APPLICATION NO.	FILING DATE	FIRST NAMED INVENTOR	ATTORNEY DOCKET NO.	CONFIRMATION NO.
10/526,971	07/19/2005	Andre Katz	0501-1126	7952
466	7590	12/11/2007		
YOUNG & THOMPSON 745 SOUTH 23RD STREET 2ND FLOOR ARLINGTON, VA 22202			EXAMINER DAVIS, MARY ALICE	
			ART UNIT 3748	PAPER NUMBER
			MAIL DATE 12/11/2007	DELIVERY MODE PAPER

Office Action Summary

DETAILED ACTION

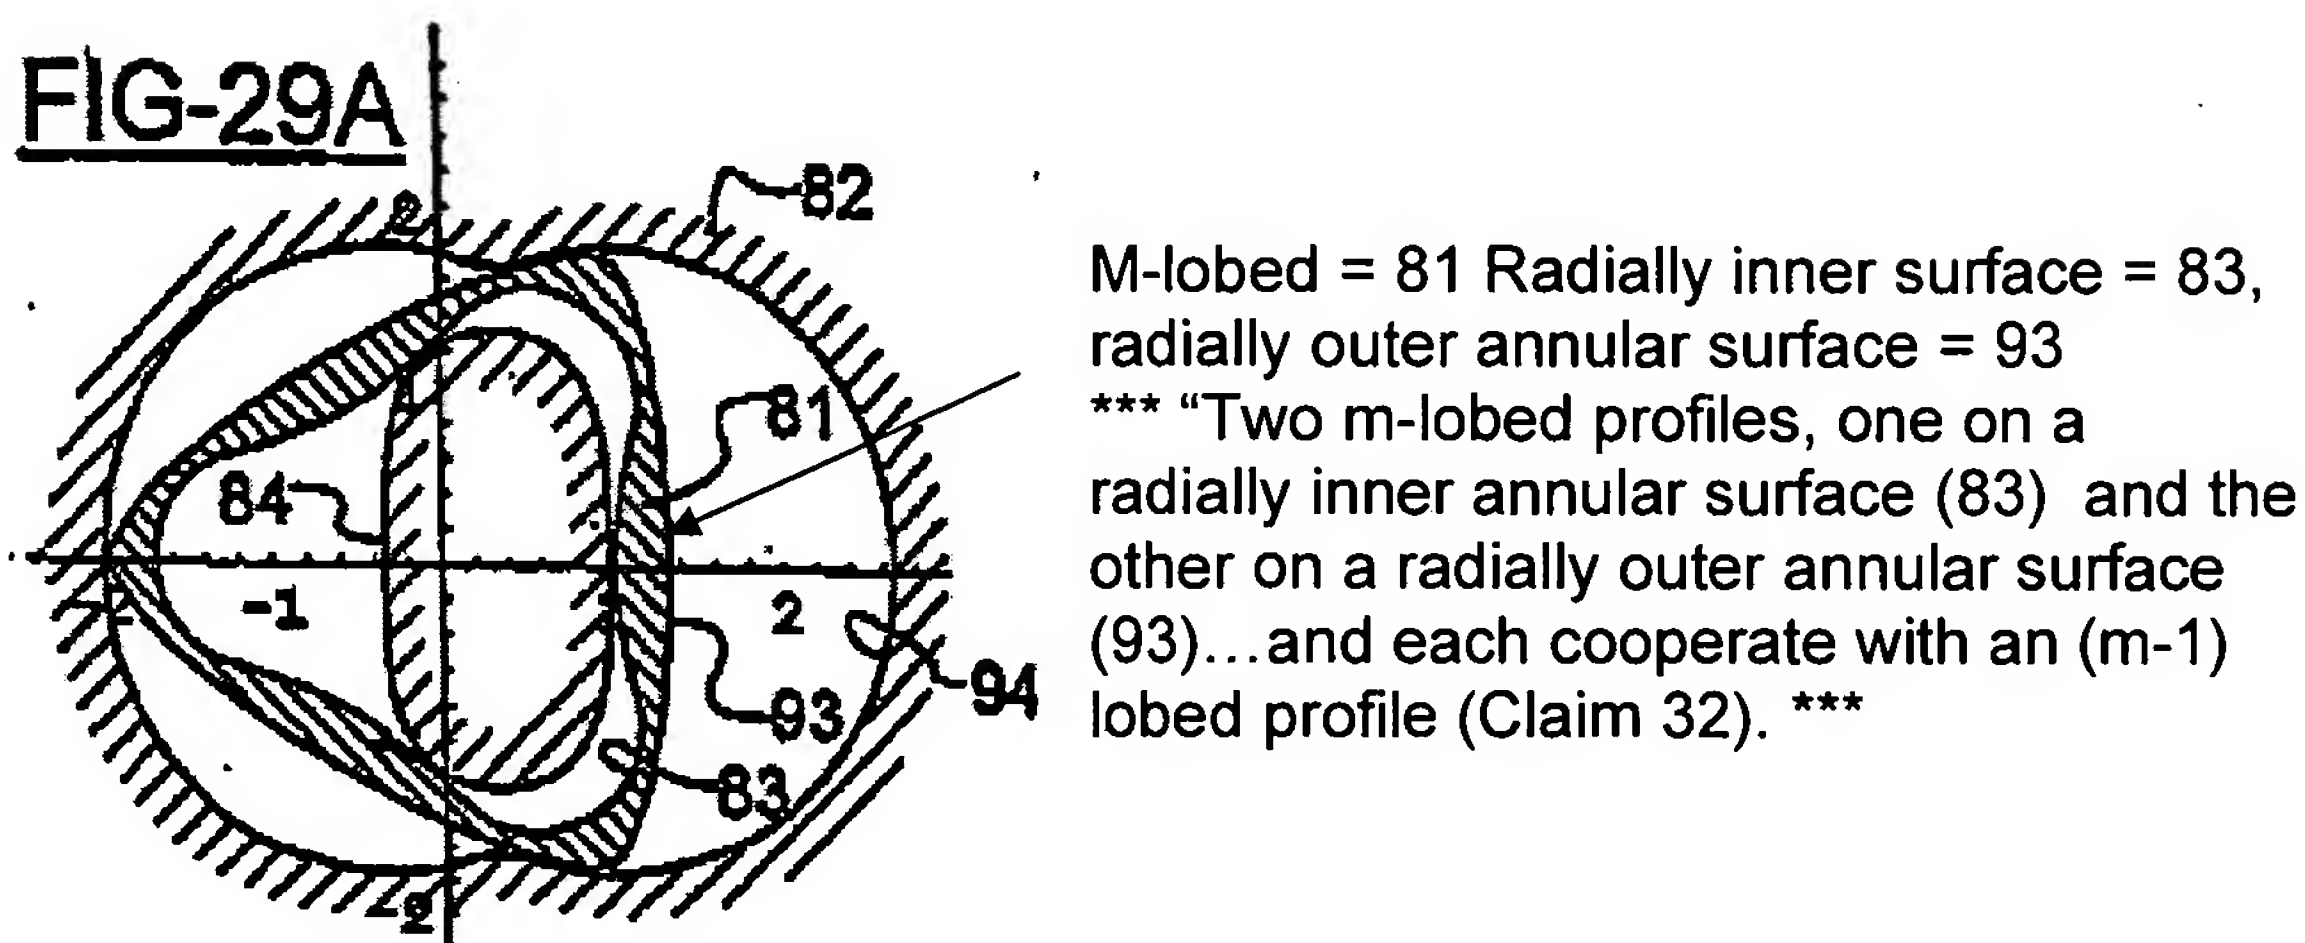
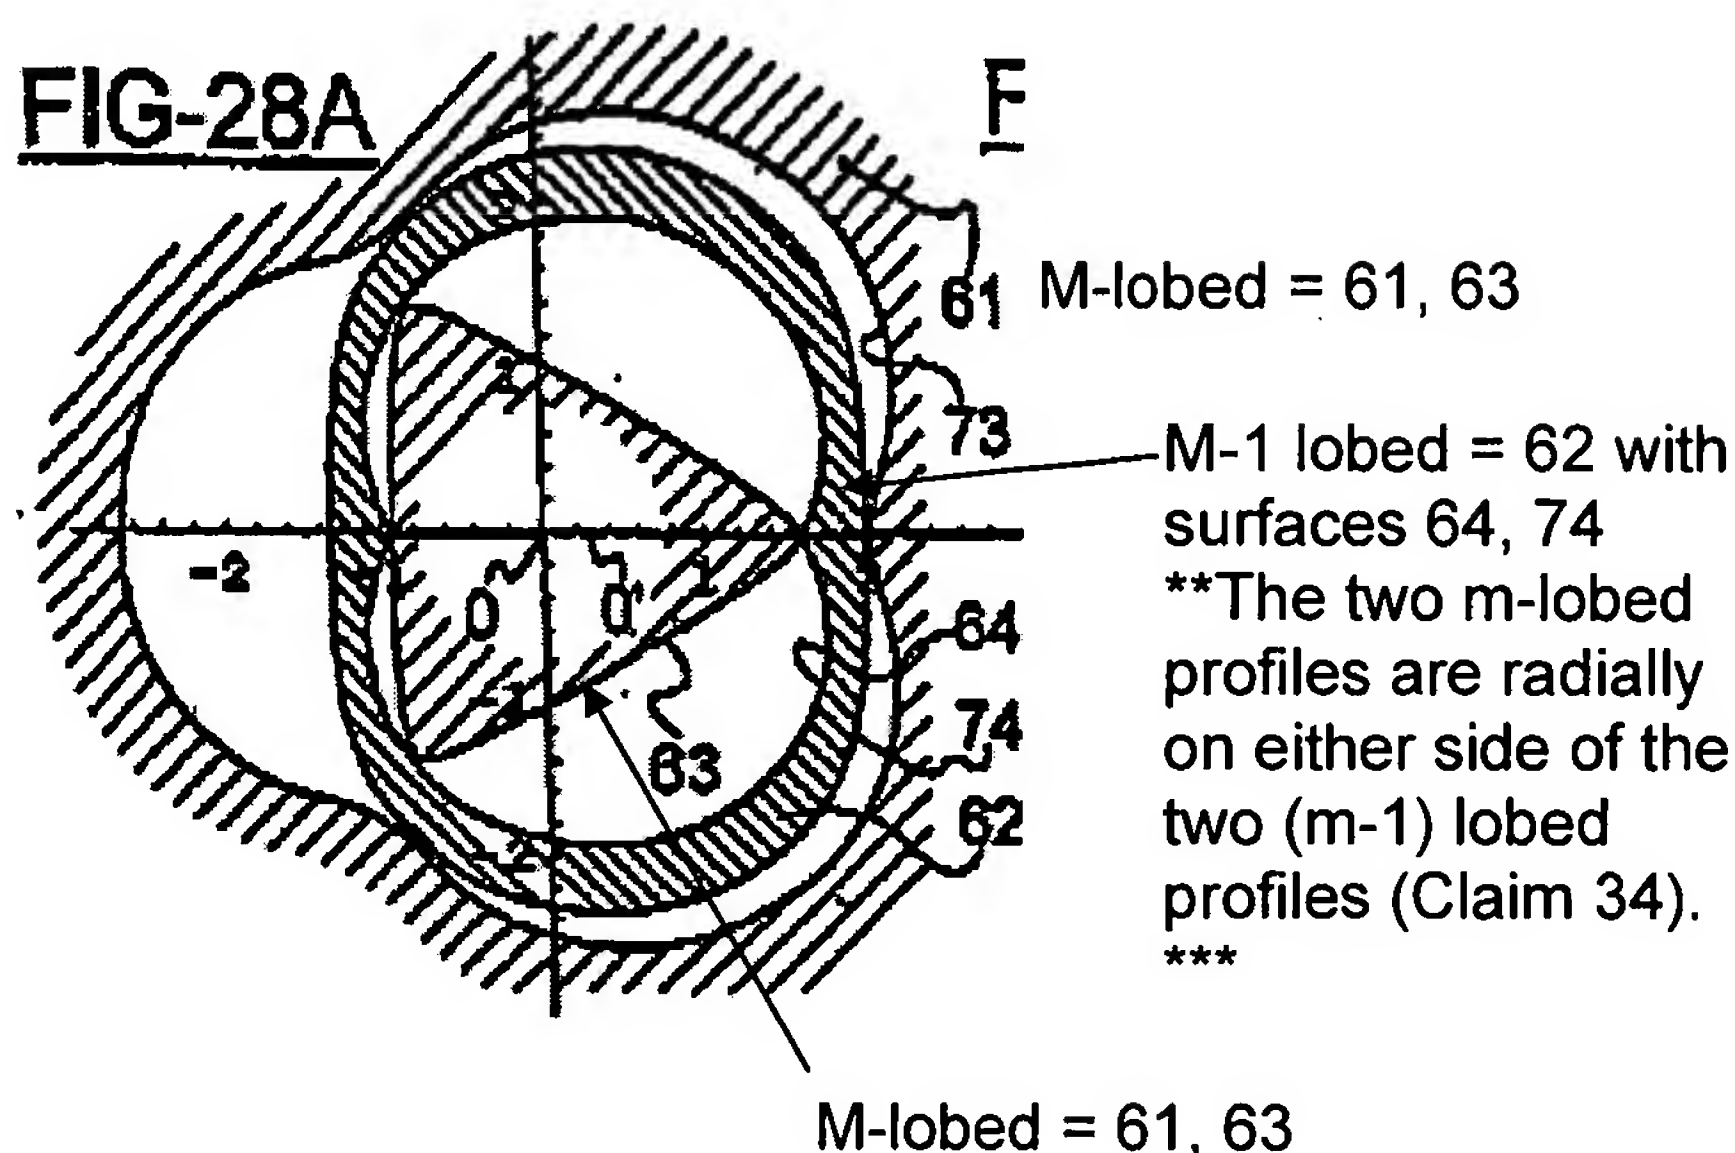
21. With regards to the 112 2nd paragraph rejection of claim 34 contradicting claim 32, and that claim 34 should not depend from claim 34, the applicant is not clear on why claim 34 would contradict claim 32. The Examiner has reproduced Figures 28A and 29A. Claim 32 recitations to: "two m-lobed profiles, one on a radially inner annular surface and one on a radially outer annular surface" is shown below as it relates to Figure 29A. This limitation in claim 32 does not describe Figure 28A, since the profile on the radially inner annular surface and on radially outer annular surface are a "m-1 lobed" and not an "m-lobed" as specified in the limitation of claim 32. Claim 34 recitation to "the two m-lobed profiles ... are radially on either side of the two (m-1) lobed profiles" is shown below as it relates to Figure 28A. The limitation of claim 34 does not describe Figure 29A and is describing Figure 28A, as shown below. Claim 32 appears to be describing Figures 29A-F, and claim 34 is describing Figures 28A-F. How can the two m-lobed profiles be on a radially inner annular surface and one a radially outer annular surface (claim 32) while also be radially on either side of the two (m-1) lobed profiles (claim 34)? Therefore, the Examiner has suggested that claim 34 is not dependent on claim 32.

Marked up Figure 2 of TAYLOR ET AL.

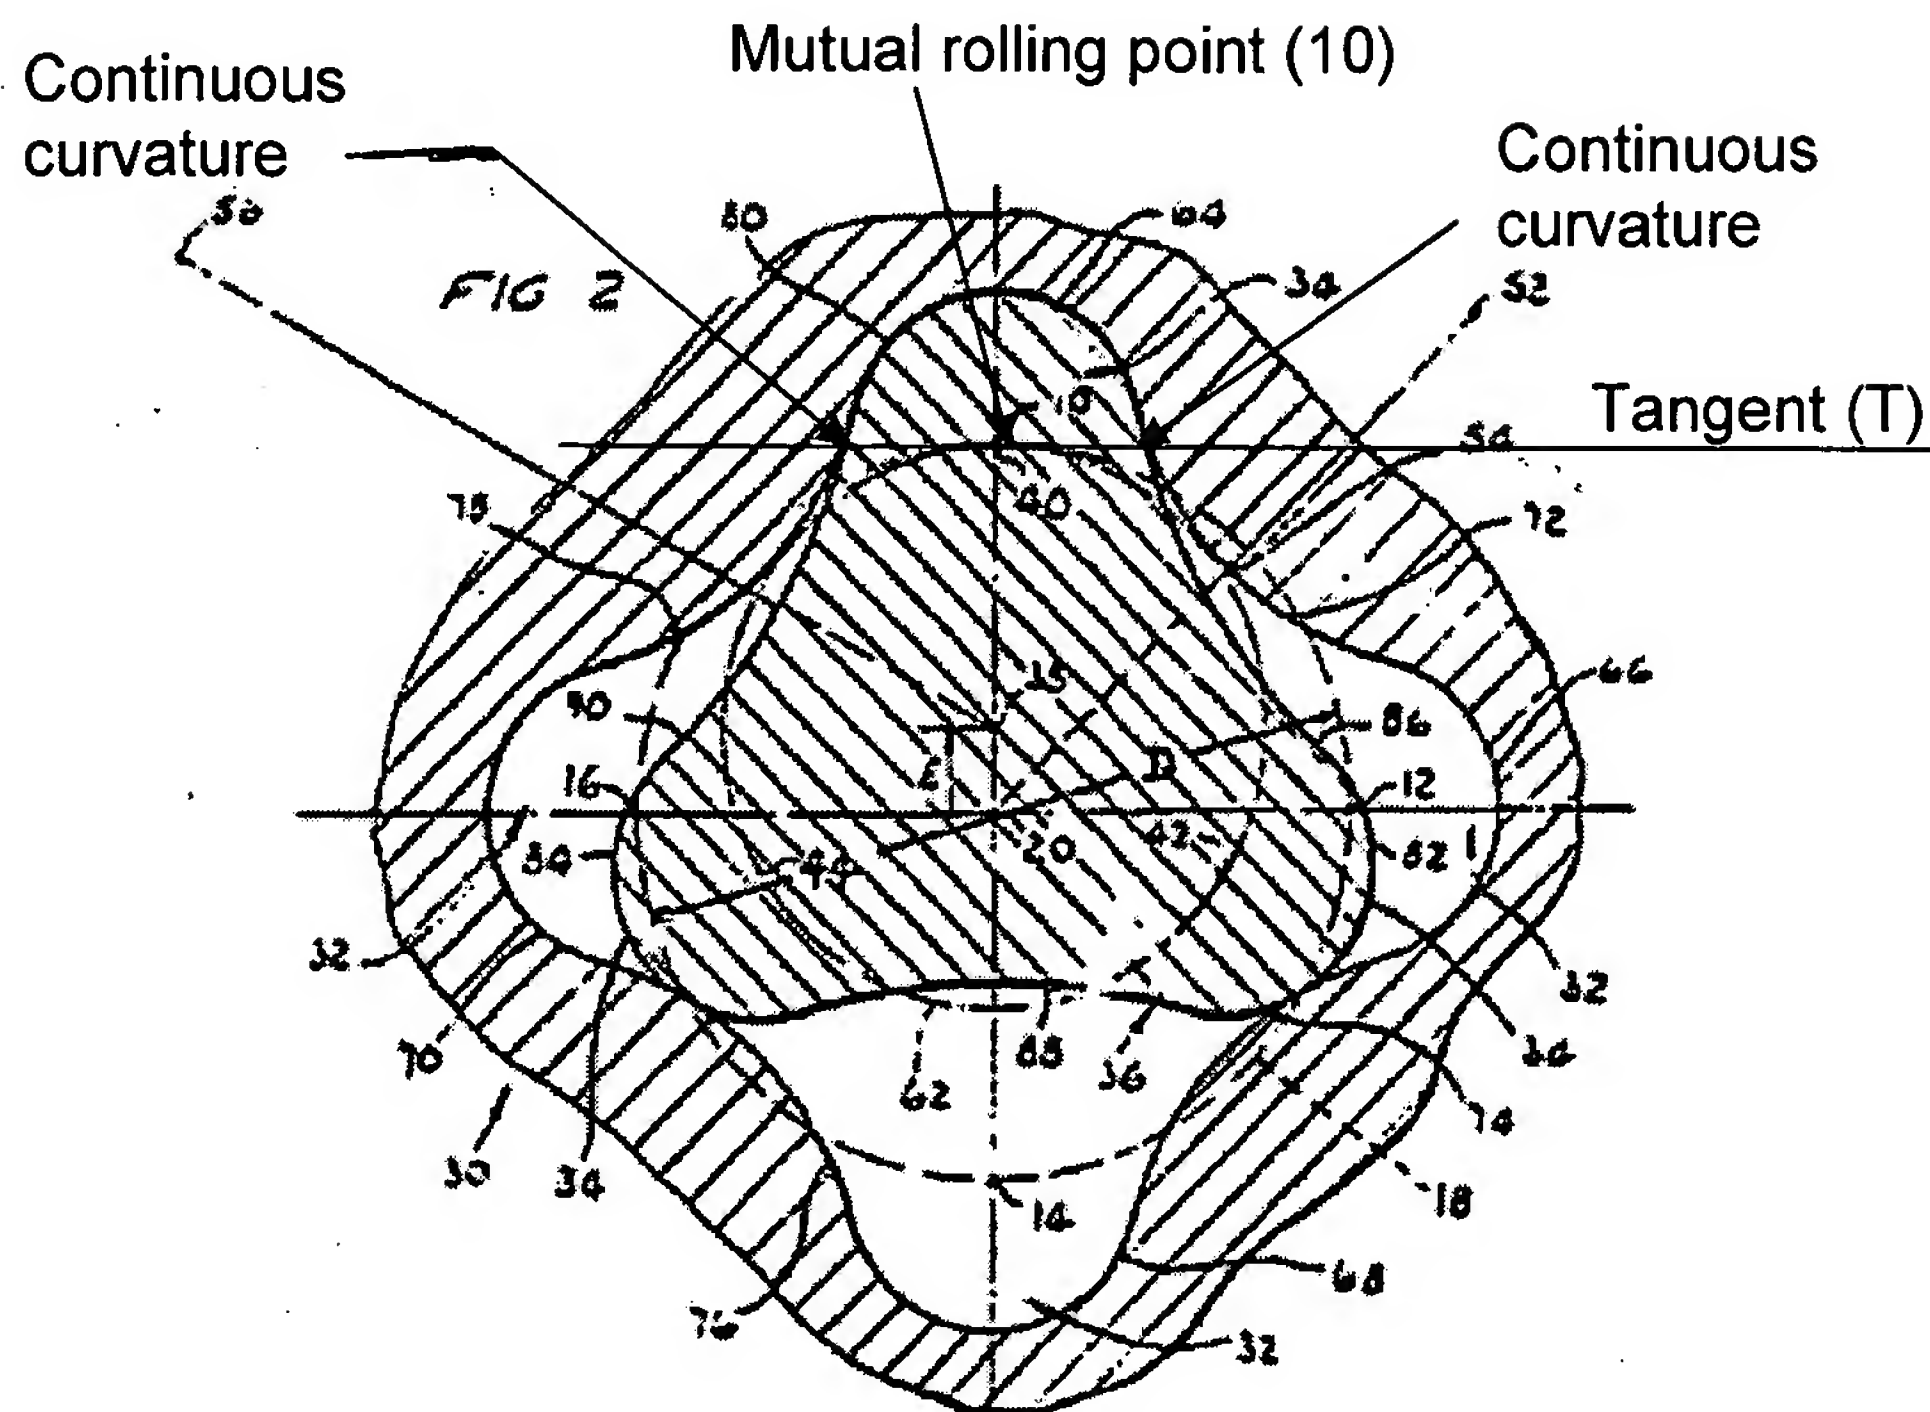
23. With regards to the 102(b) rejection of claim 1, the applicant argues that Taylor's Figure 2 at the contact point that the contact surfaces are oblique and therefore the local curvatures cannot be centered on the rolling point. Applicant further argues that radius of curvature of both contact surfaces at the contact position be equal to the

24. Applicant further argues that the curvature is discontinuous at the contact point since the curvature changes from concave to convex and that the embodiments of TAYLOR ET AL could not operate. The Examiner disagrees with the applicant's argument, see marked up Figure 2 that shows that the curves are continuous at the contact point. Furthermore, the Examiner disagrees with the conclusion made by the applicant that if the curvature changes from concave to convex that the curvature is not continuous. In addition, the argument with respect to the why TAYLOR ET AL can not operate is not persuasive.
